Modification	At what stage is this document in the process?
<p>DCRP/MO/19/05 Report to Authority DCode EREC G99 Fast Fault Current Injection Modifications Modifications to The Distribution Code and EREC G99 of the requirements for Fast Fault Current Injection.</p>

The purpose of this document is to assist the Authority in its decision to implement the proposed modification to Engineering Recommendations G99. The proposed modification aims to clarify (but not change) the requirements for fast fault current injection with which Power Park Modules of Type B, C and D need to comply with.

Date of publication: 20 June 2019

Figure 5.0

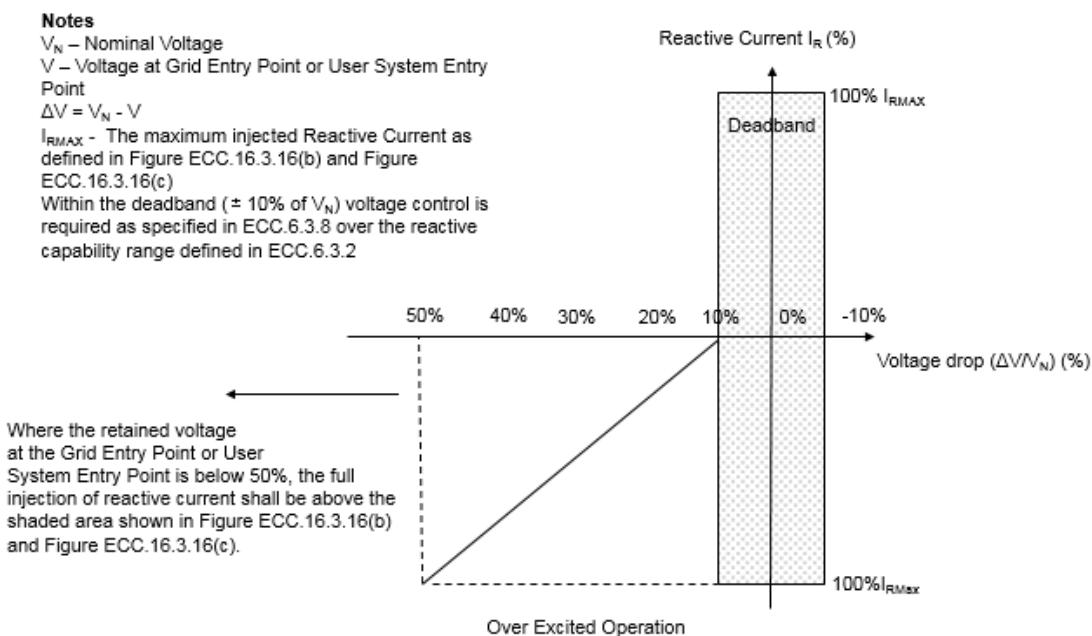
These concepts were further explored and presented to the workgroup in September 2018, which resulted in the following revised voltage / reactive current diagram shown in Figure 5.0.

In addition, corresponding legal text was also developed. At this stage, a number of Workgroup members expressed concern over the behaviour of Power Park Modules and HVDC Systems during unbalanced faults and that the performance of plant can vary quite significantly between full converter based plant or DFIG derived equipment. A number of concerns were also expressed with regard to operation between steady state and under faulted conditions.

At this stage two options were suggested by the workgroup. One was to consider the approach adopted as discussed in September, another was to adopt an approach similar to that proposed in EN 50549. EN50549 is much more specific in its treatment of unbalanced injection and the use of positive and negative components. These issues start to become complex very quickly and whilst two versions of the legal text were drawn up (ie one drawn up based on the discussion held in September and one drawn up based on EN 50549) the general view was that the initial approach suggested in September should be the one taken forward as the EN50549 is complex with the conclusion that any form of individual phase behaviour would be outside the scope of the workgroup.

However some very useful findings came out of these discussions in which it was agreed that in adopting the September option, the deadband should be changed to insensitivity and a number of detailed examples should also be prepared outlining how a plant would be expected to respond when operating in full lead or full lag and then subsequently exposed to range of voltage dips of various degrees ranging from 85% retained voltage to 10% retained voltage.

Figure 6.0

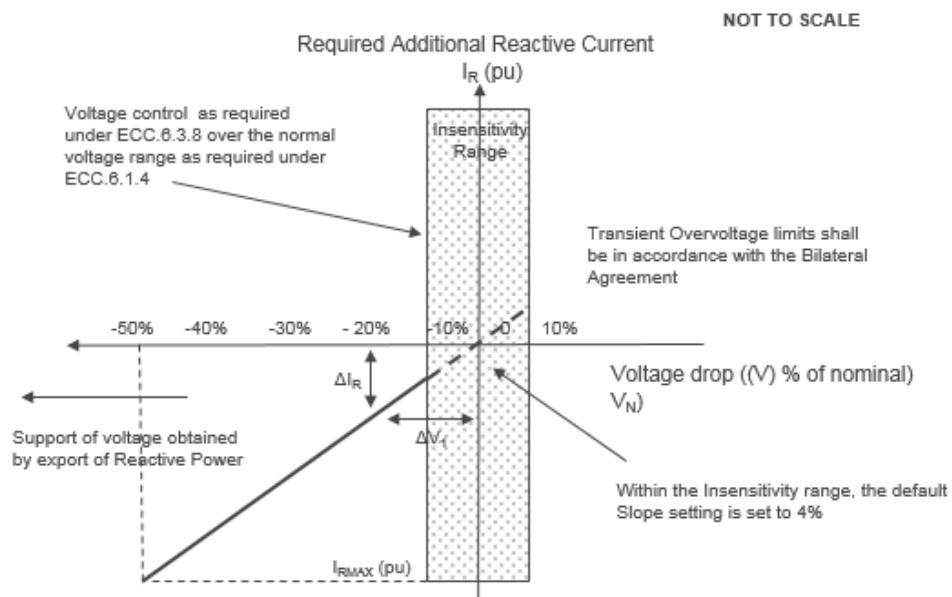
The revised voltage / reactive current characteristic is shown in Figure 6.0 below.

At this point a number of stakeholders expressed concern over the mode change at retained voltages of 50% and at this meeting it was suggested that a formula based approach should be used over the entire voltage operating range. As a result, the following approach formula was proposed which would apply over the full voltage range.

Figure 9.0

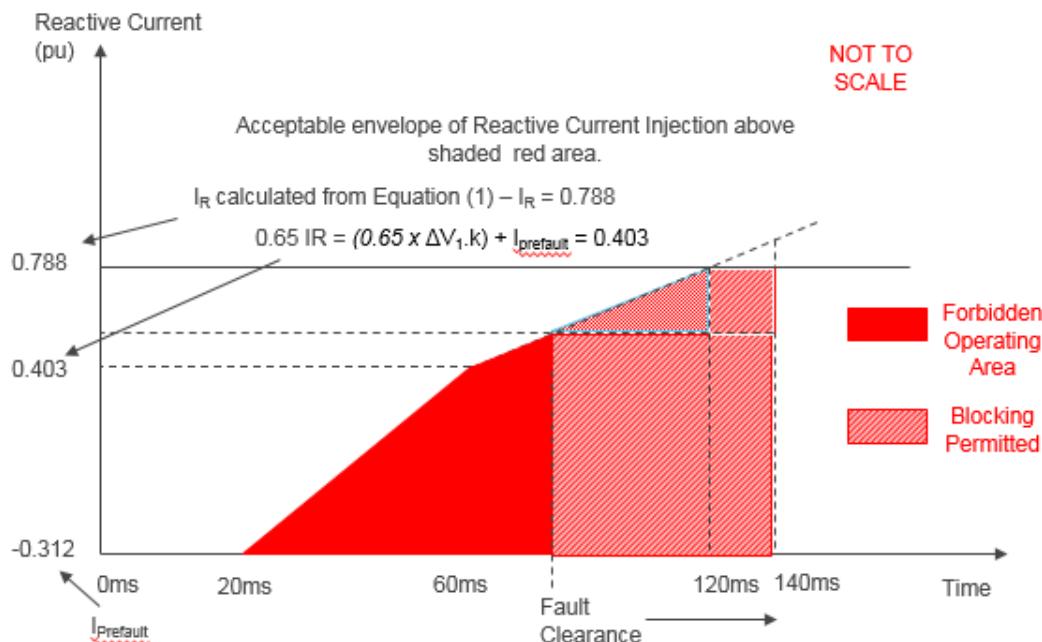
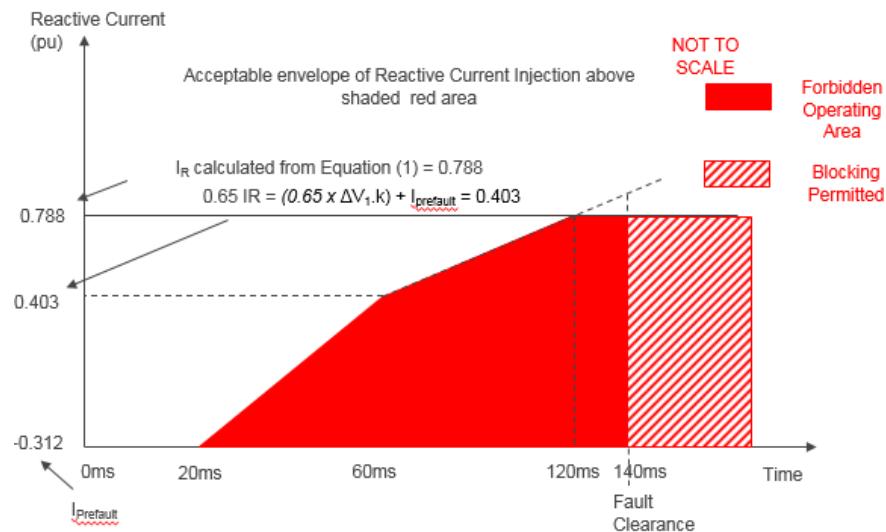
- Wind farm is operating at 100MW output and 0.95 PF leading (ie 32.8MVAr or import to the System)
- $I_R = \Delta V_1 \cdot K + I_{prefault}$
- And $\Delta V_1 = V_{prefault} - V_{insensitivity} - V_{retained}$
- If $V_{Prefault} = 1.04\text{ p.u}$ and $Q_{max} = 0.95\text{ PF}$ lead on a 4% droop
- $V_{insensitivity} = 0.1\text{ p.u}$
- In this case the retained voltage ($V_{retained}$) is 0.5 pu
- $\Delta V_1 = V_{prefault} - V_{insensitivity} - V_{retained} = 1.04 - 0.1 - 0.5 = 0.44$
- $I_{prefault} = \sin(\arccos 0.95) = -0.312\text{ pu}$
- $I_R = \Delta V_1 \cdot K + I_{prefault} = 0.44 \times 2.5 - 0.312 = 0.788\text{ pu}$
- $IR \text{ at } 60ms = (0.65 \times \Delta V_1 \cdot K) + I_{prefault} = (0.65 \times 2.5 \times 0.44) - 0.312 = 0.403\text{ pu}$

Which when superimposed on Figure ECC.6.3.16(b) and ECC.6.3.16(c) results in Figure 9.0 and Figure 10.0

As can be seen in the leading example the injection of reactive current is lower than that in the lagging case which means that the gain factor (k) would need to be increased if full reactive current was to be achieved for a voltage drop of 50%. Whilst it is accepted that the delta (ie the reactive current swing) between the two is broadly similar, full reactive injection would be required under a faulted condition.

Figure 11.0

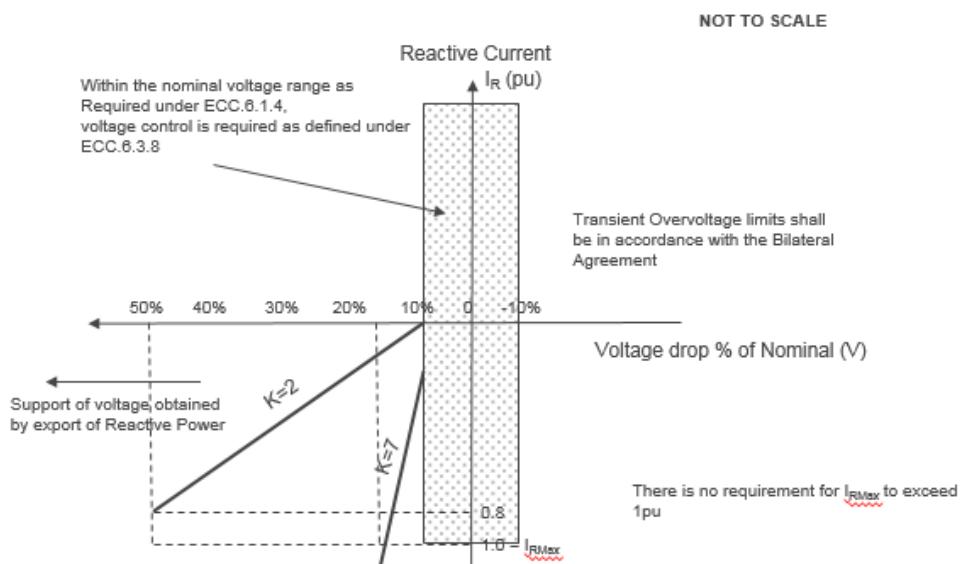
To address this concern, the effect can be limited by changing the formula so that the additional reactive current becomes $I_R = \Delta V_1.k + |I_{\text{Prefault}}|$ where $|I_{\text{Prefault}}|$ becomes the modulus of I_{Prefault} and ΔV_1 simply becomes $V_{\text{Prefault}} - V_{\text{Retained}}$. Whilst there will be a slight difference between the reactive current injected between unity power factor and full lead or full lag, full reactive current would be obtained for a retained voltage of 0.5pu. This also means the k factor can be retained at 2.5 although in simplifying the formula this would require the need to make sure developers and manufacturers are comfortable with the transition from the steady state mode between the normal operational voltage of 0.9pu to 1.05pu and a faulted condition. The revised voltage drop / reactive current characteristic is shown in Figure 11.0.

Figure 14.0

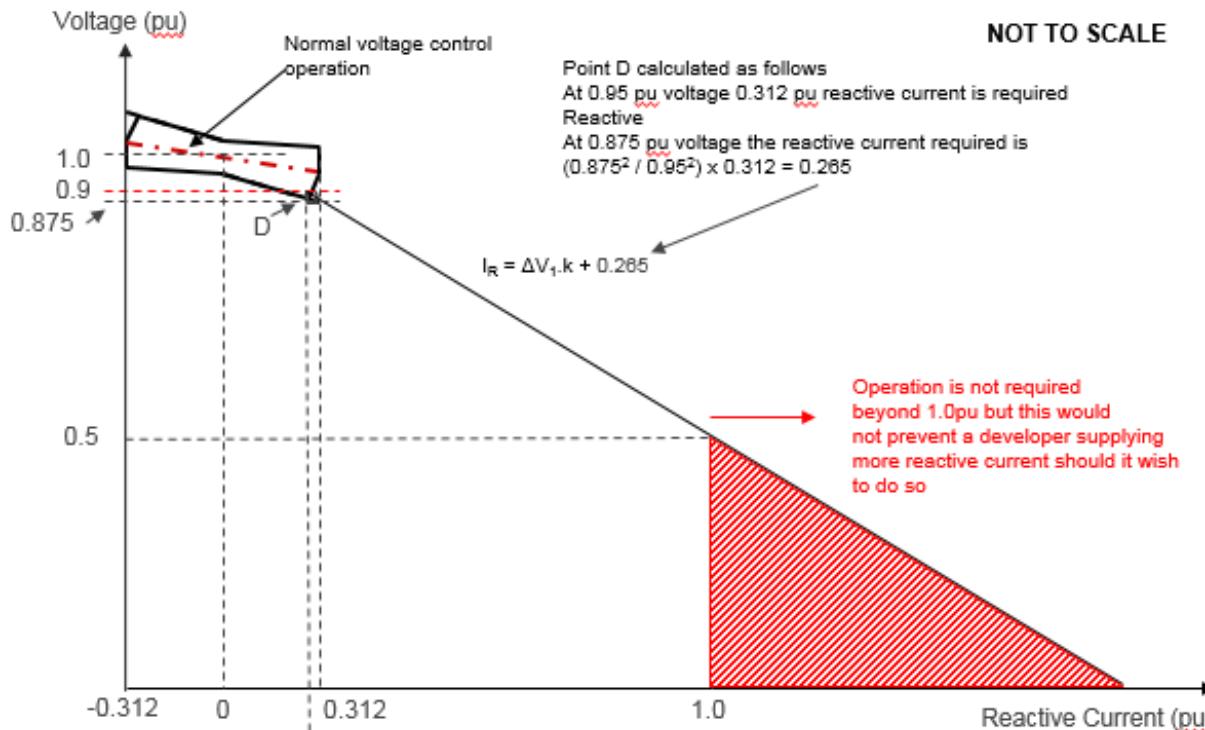
To investigate potential hunting issues figure 14.0 below shows a more detailed representation of the requirement between steady state operation and a fault ride through condition.

The advantage of this approach is that the reactive current injection will be the same irrespective of the pre fault operating point. In addition, as soon as the voltage drops to 0.5pu with a gain factor of 2.5, a reactive current injection of 1.0pu will be delivered.

The problem with this approach is that some developers and manufacturers could struggle with the requirement especially in the common case for distribution connected modules if the plant was operating in power factor control mode or reactive power control mode and the Connection Point Voltage remained at 0.9pu and the generator was operating under full import – although such an operating point itself is not likely. To address this issue, it was suggested at the February 2019 Workgroup meeting that the normal voltage operating envelope should be retained and an envelope of operation defined between the two black lines (ie starting at the extreme ends of the voltage operating range at 0.9pu and 1.1pu voltage and ending at the intersection of the 0.5 pu voltage and 1pu reactive current point). This characteristic is shown in Figure 15.0 below but would at least ensure a progressive injection of reactive current between 0.9pu and 0.5 pu voltage whilst ensuring below 0.5pu voltage the full 1.0pu reactive current would be delivered.

As part of this approach the proposal was for the reactive current injection to be defined by the following formula.

$$I_R = \Delta V_1 \cdot k + 0.265$$

$$\Delta V_1 = 0.9 - V_{\text{retained}}$$

Figure 16.0

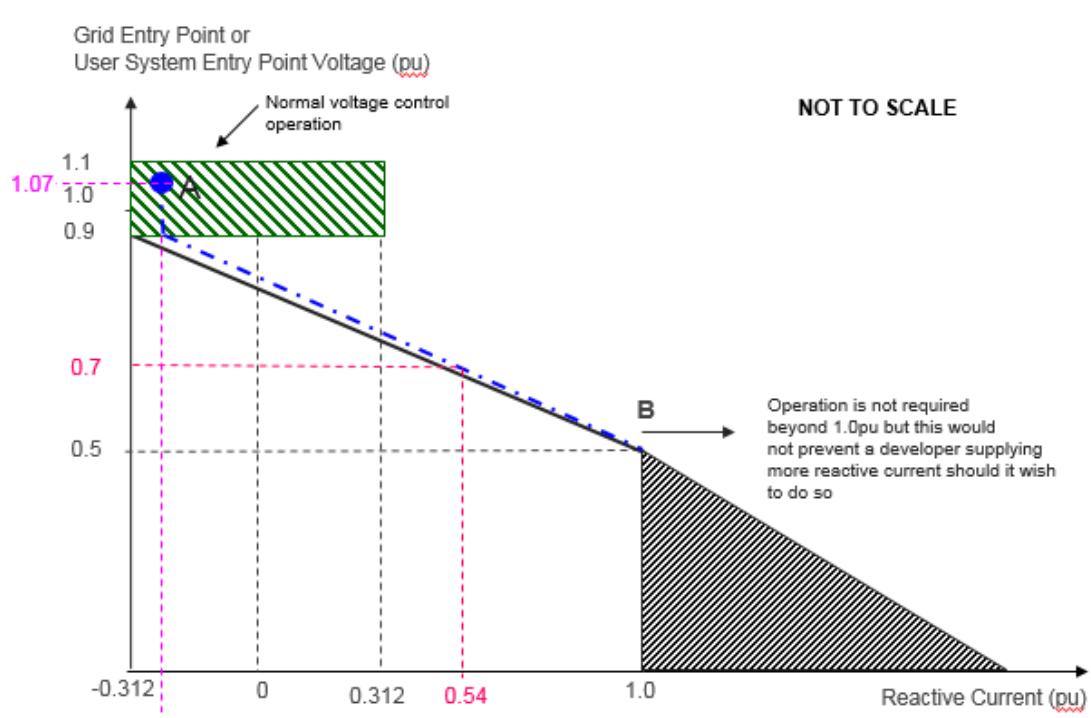
To address this concern, two points were raised. The first, that irrespective of the operating point within the normal voltage operating range, the locus of I_R should converge to the 0.5pu voltage / 1.0pu reactive current coordinate so as not solely to give a minimum performance requirement. Secondly, some concern was expressed as to how this requirement would interface with Figures ECC.6.3.16(b) and ECC.6.3.16(c). A comment was also noted that the upper boundary would not be required.

Figure 16 shows an illustrative requirement of the behaviour expected from a plant operating in the leading mode of operation and the I_R value required when subject to a voltage dip of 0.7pu at the connection point.

In this case, the pre-fault operating condition is assumed to be arbitrarily operating at 1.07pu voltage and the reactive current is -0.3pu. This is shown by the blue circle in the green shaded area. The reactive current injection can take any shape being linear or non-linear but would need to be on or above the blue dashed line shown in Figure 16 constructed between points A and B.

For the purposes of this example we are assuming the Power Park Module is exposed to a voltage dip of 0.7 pu. At 0.7pu voltage this corresponds to I_R of 0.54 pu reactive current as shown by the purple dashed line and where it intersects with the blue dashed line. I_R would need to be greater than or equal to 0.54.

Figure 19.0

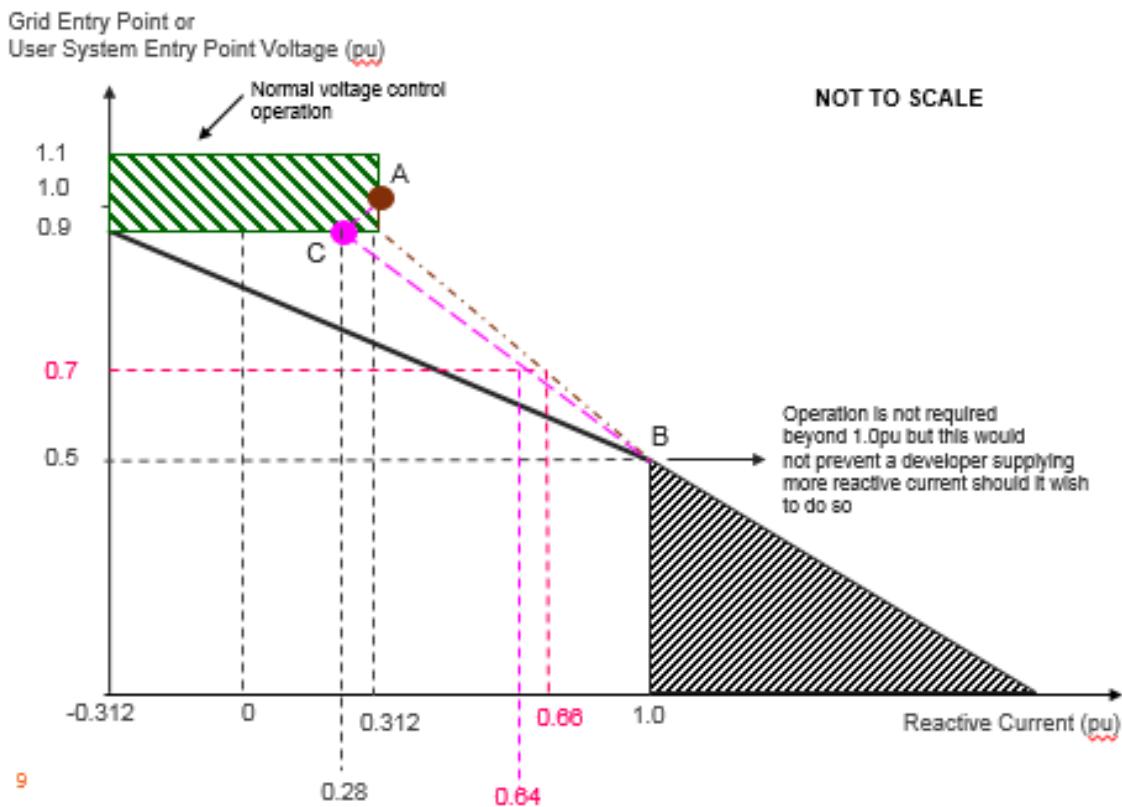
Example 2 is shown in Figure 19 which shows an illustrative requirement of the behaviour expected from a plant operating in the lagging mode of operation and the resultant I_R required when subject to a voltage dip of 0.7pu at the connection point.

In this case, the pre-fault operating condition is assumed to be arbitrarily operating at 0.96pu voltage and the reactive current is 0.312pu. This is shown by the brown circle in the green shaded

area. Applying the same approach as in example 1, the brown dotted line constructed between points A and B of Figure 19 indicates the I_R required as a function of the retained voltage. However we need to ensure that the rating of the plant is not exceeded and therefore an additional pink line at point C is drawn. This reduction is permitted as the Grid Code requires full reactive capability to be provided over a voltage range of 1.05pu to 0.95pu. Below 0.95pu voltage, a drop in the reactive power export is permitted as it is possible a number of developers may choose to use fixed capacitors to contribute to voltage control in which case the reactive power falls off with the square of the voltage. This characteristic showing the allowed fall in reactive power is shown in Figures ECC.A.7.2.2b and ECC.A.7.2.2c of Appendix 7 of the Grid Code European Connection Conditions.

For the purposes of this example, we are assuming the Power Park Module is exposed to a voltage dip of 0.7 pu. At 0.7 pu voltage this corresponds to a I_R of 0.64 pu reactive current as shown by the purple dashed line and where it intersects with the pink dashed line at 0.7pu voltage.
